STATE OF ILLINOIS
DEPARTMENT OF TRANSPORTATION

Contract # 70125

**CONCRETE PARAPET
SLIPFORMING OPTION**

Added Sheet - 2-24-05

SECTION
(Showing dimensions)

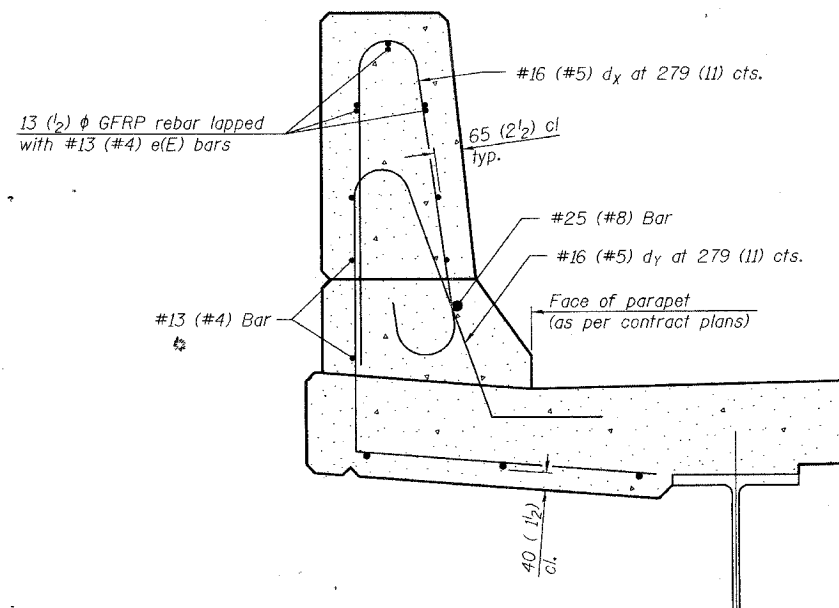
GENERAL NOTES
All dimensions shall remain the same as shown on contract plans, except dimensions A and B which are to be revised as shown to provide additional clearance. Additional concrete needed to revise dimension A and B = 0.0422 m³/m (0.165 cu. yds./ft.) of parapet. Place aluminum sheet in curb portion at and near piers. Full thickness saw cut at all other locations. Adjust/add joint locations to maintain 3 to 6 meter (10 to 20 foot) spacing.
